Groundwater Transfer Review Summary Form

Transfer/PA # T- 14541

Application: T-14541

Applicant Name: City of Bend

Transfer Map

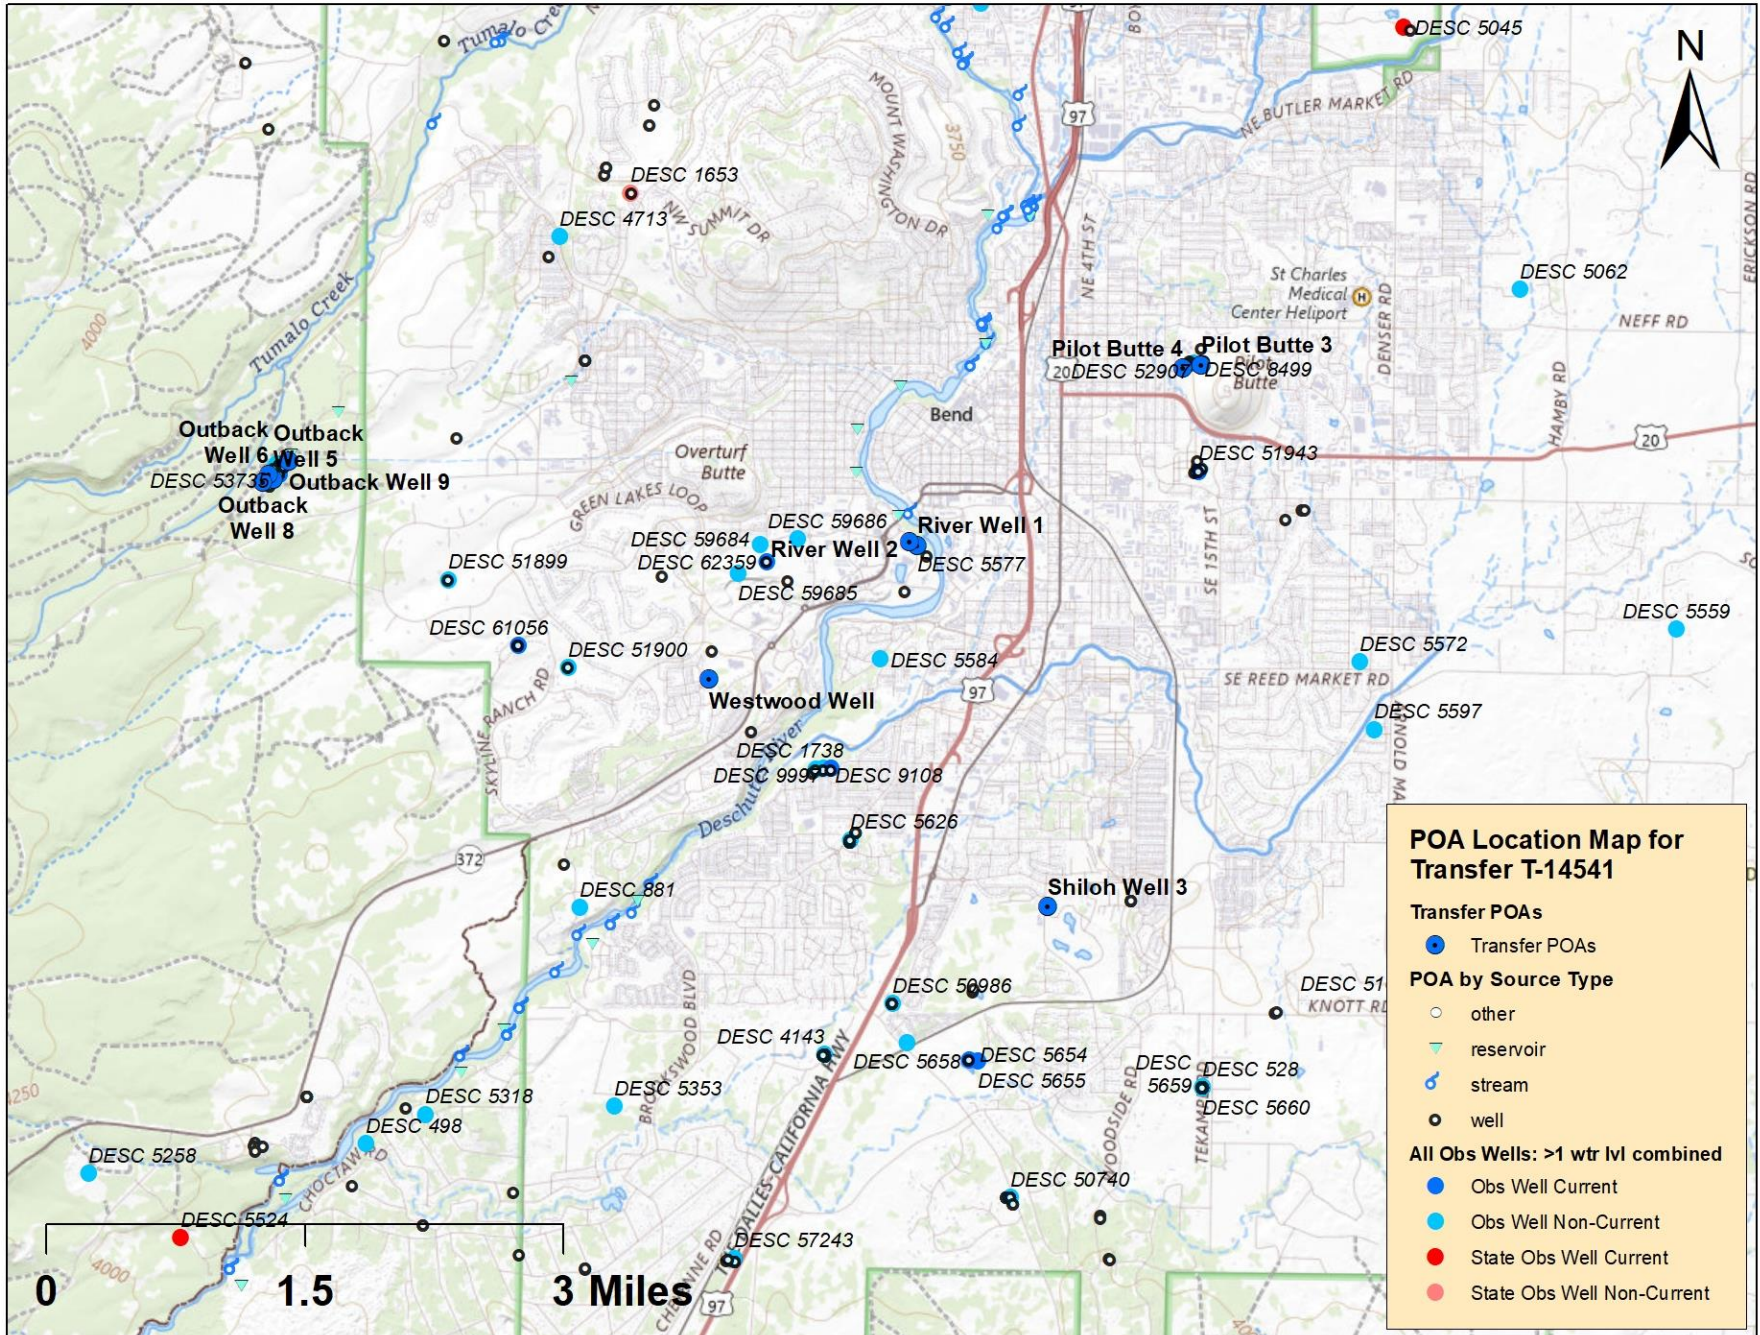
2. Will the proposed POA develop the same aquifer (source) as the existing authorized POA?
 Yes No Comments: All authorized and proposed POAs produce groundwater from the Deschutes regional groundwater system across a distance of approximately five miles from the Outback station to the Pilot Butte well cluster.

Yes No Comments: It is well documented that the target aquifer begins discharging to the Deschutes and Crooked Rivers near their confluence at a distance of ~25 miles north of the wells involved in this transfer. Some of the proposed changes would move groundwater production closer to that point of hydraulic connection with surface water, which would quicken interference with those streams.

Additionally, the Outback wells are located within one mile of Tumalo Creek which does receive groundwater inflow. Considering that any mapped springs are located far upstream from the Outback wells and that the groundwater elevations at Outback wells (3400-3500 feet amsl) are well below the elevation of Tumalo Creek near the Outback wells (3800-3900 feet amsl), the target aquifer appears to have dropped hundreds of feet below the stream network until the confluence area. Thus, there is negligible hydraulic connection between Tumalo Creek and the Outback wells.

Provide context for minimal/significant impact: Assuming that there is no increase in total groundwater allocated under this permit (no enlargement), the change in location of pumping (within a five mile range) compared to the distance to the confluence area (~25 miles) will have a minimal impact on interference with that groundwater inflow.
